**TOWN OF NEWBURGH
PLANNING BOARD
TECHNICAL REVIEW COMMENTS**

PROJECT: WEBB PROPERTIES
PROJECT NO.: 14-10
PROJECT LOCATION: SECTION 97, BLOCK 2, LOTS 13.22, 35 & 43
PROJECT REPRESENTATIVE: A. DIACHISHIN & ASSOCIATES
REVIEW DATE: 26 NOVEMBER 2014
MEETING DATE: 4 DECEMBER 2014

Re: Site Plan for Webb Properties, Inc., Town of
Newburgh Planning Board **Project Number 2014-10.**

NARRATIVE

Site Lighting Plan
for
Webb Properties, Inc.
Auto Park Place
Tax Map: Section 97, Block 2, Lot 35

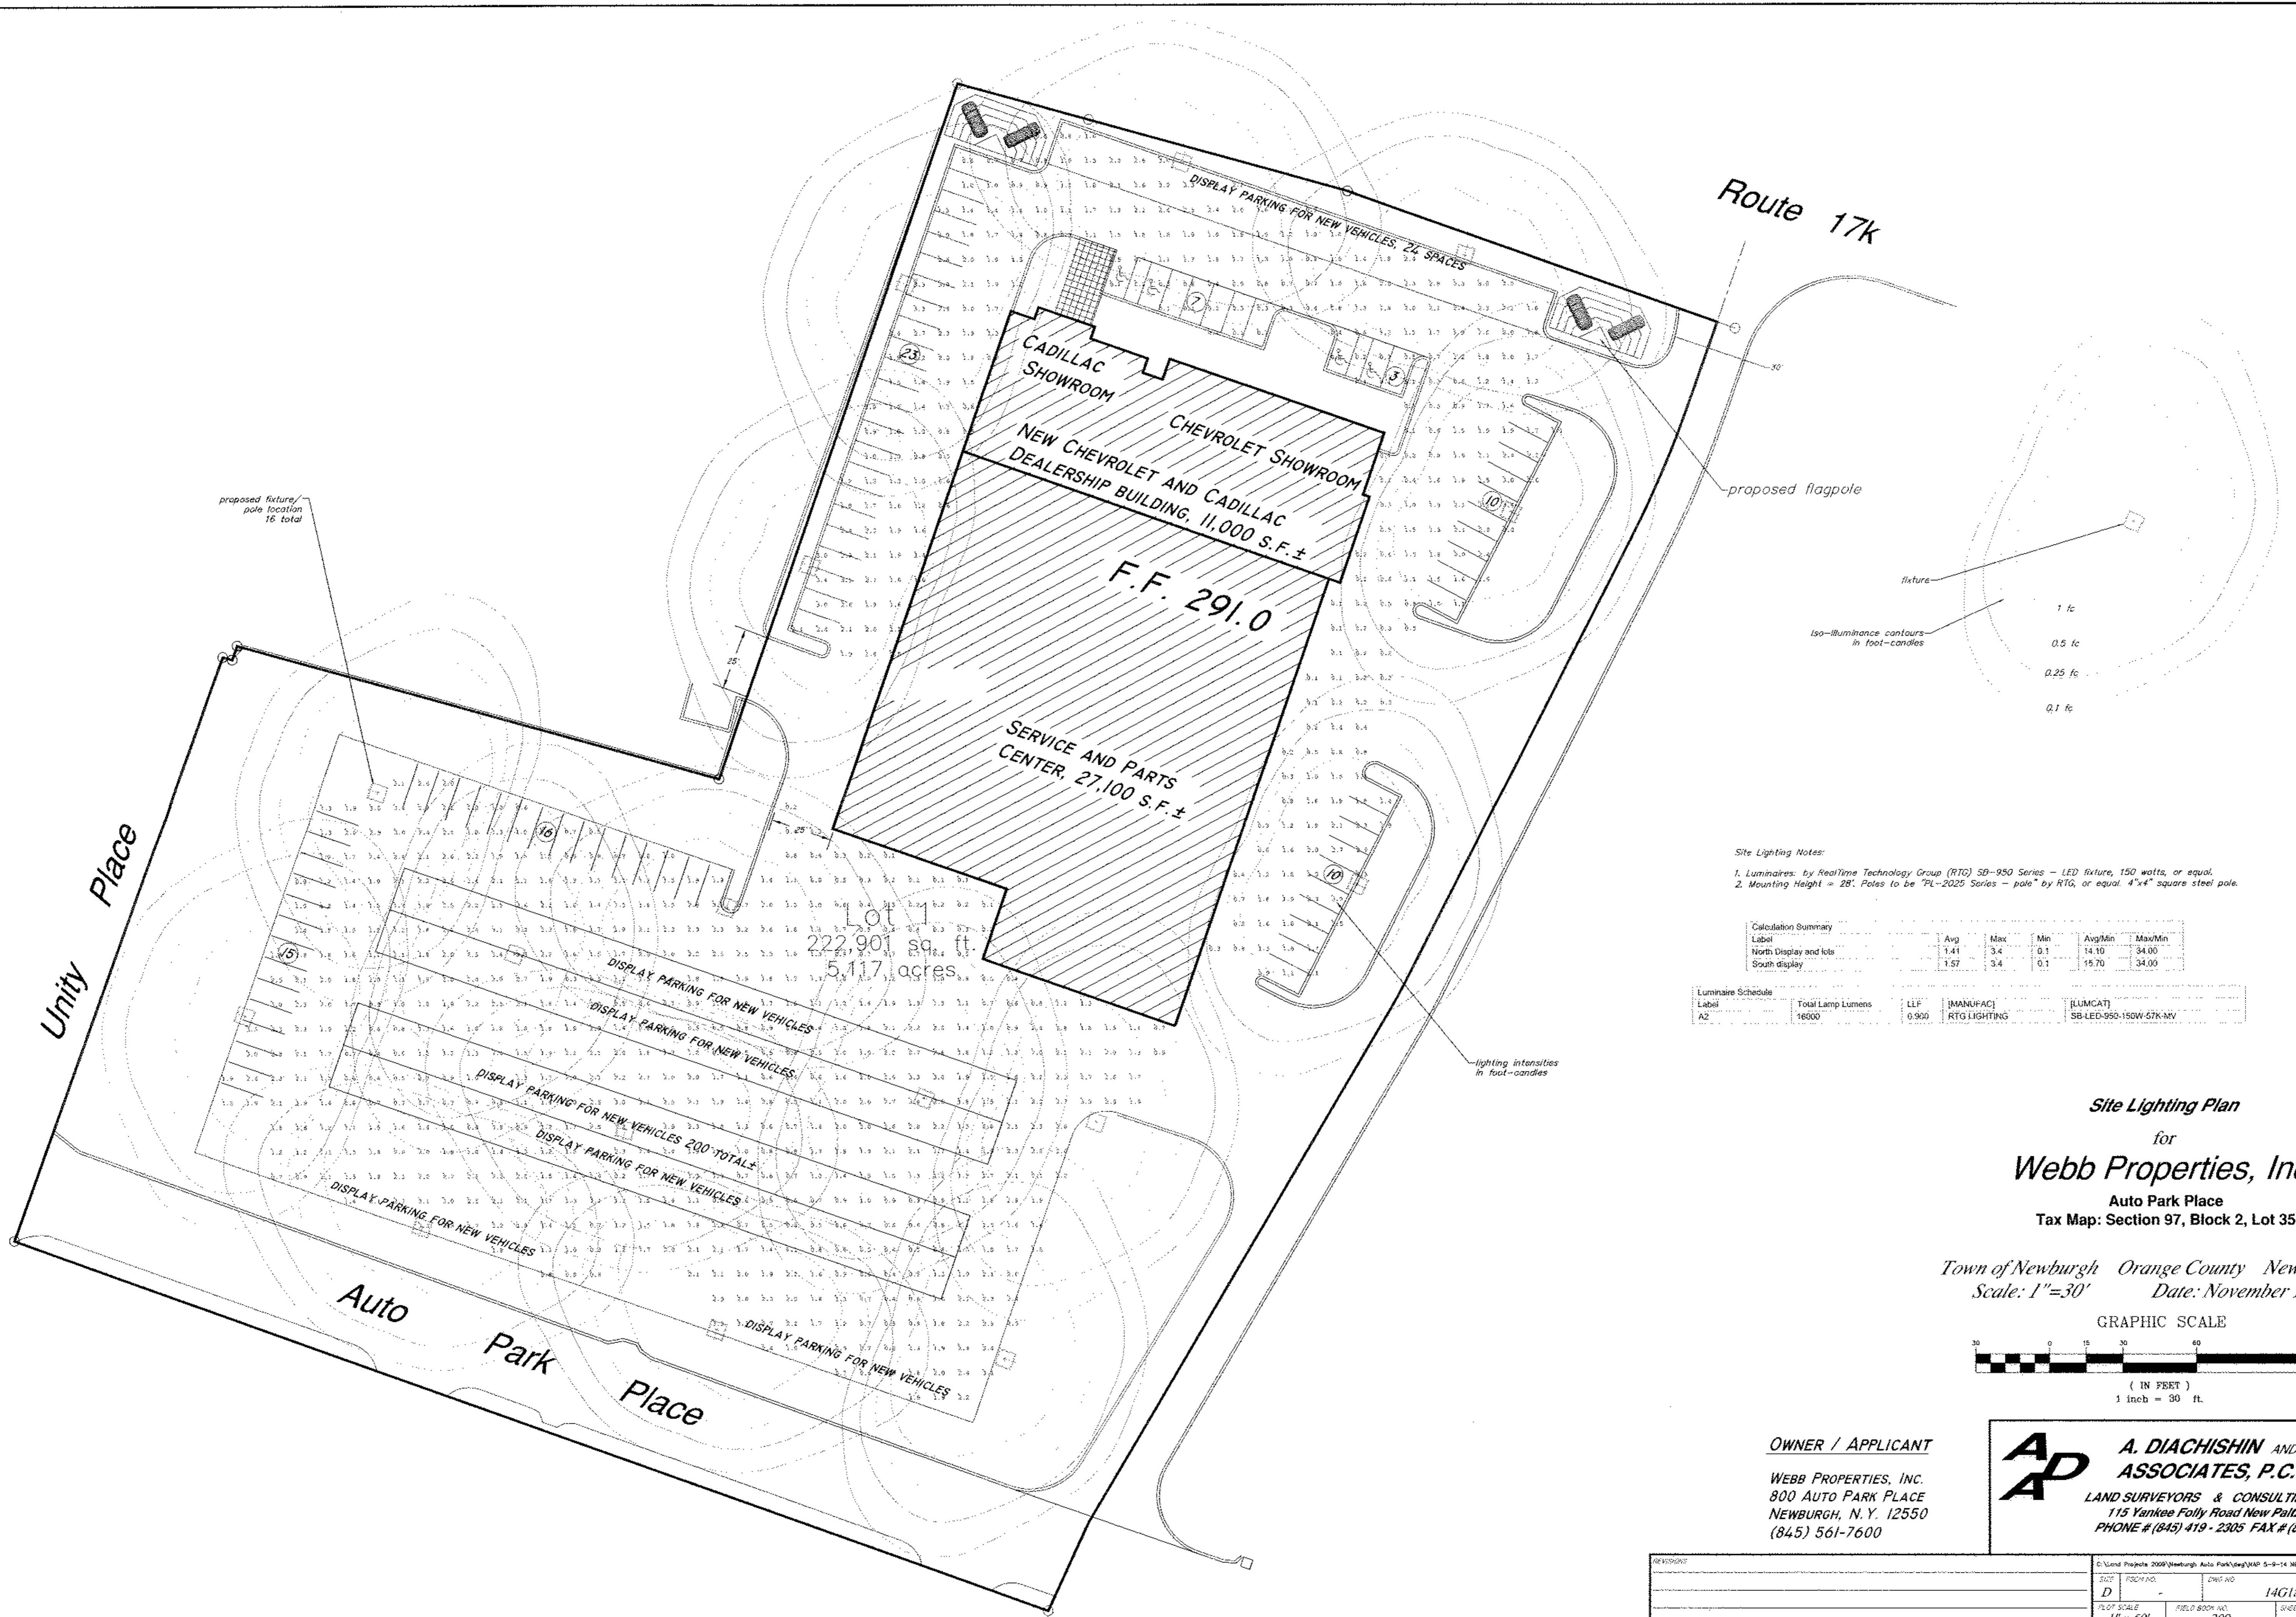
8. Light poles are clarified and specified.
9. Lighting plan is now included.
10. Existing landscaping along Auto Park Place and notes have been added. grading has been revised.

1. Luminaires: by RealTime Technology Group (RTG) SB-950 Series - LED fixture, 150 watts, or equal.
2. Mounting Height = 28'. Poles to be "PL-2025 Series - pole" by RTG, or equal 4"x4" square steel pole.
